SUBJECT: FCC Class II Permissive change for FCC ID: 2A8ZE02

We, the undersigned, would like to request a Class II Permissive Change for the FCC ID: 2A8ZE02, which was originally granted on 10/21/2024.

New Circuit board:

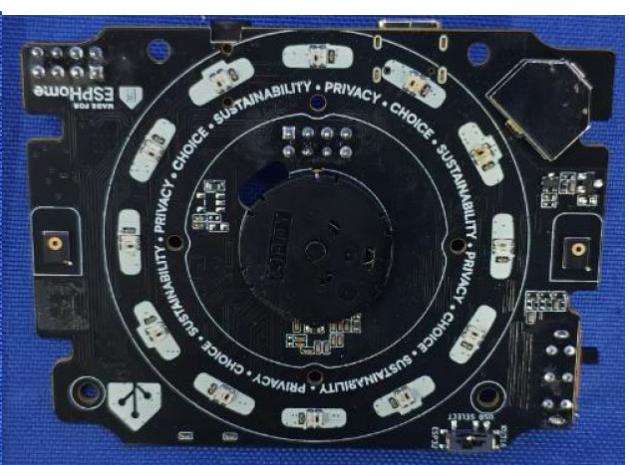
Please be informed that our major change in equipment under this application are as follows:

1. Change the OR of FB12 to 2A PPTC
2. Add bidirectional 5V TVS
3. Remove the 4.7uF capacitor of VBUS
4. Change SY80004 of U10 to TPS62827
5. Change ETA3410 of U12 to TP62065
6. Separate the chassis of USB C and add 1NF and 1M resistors
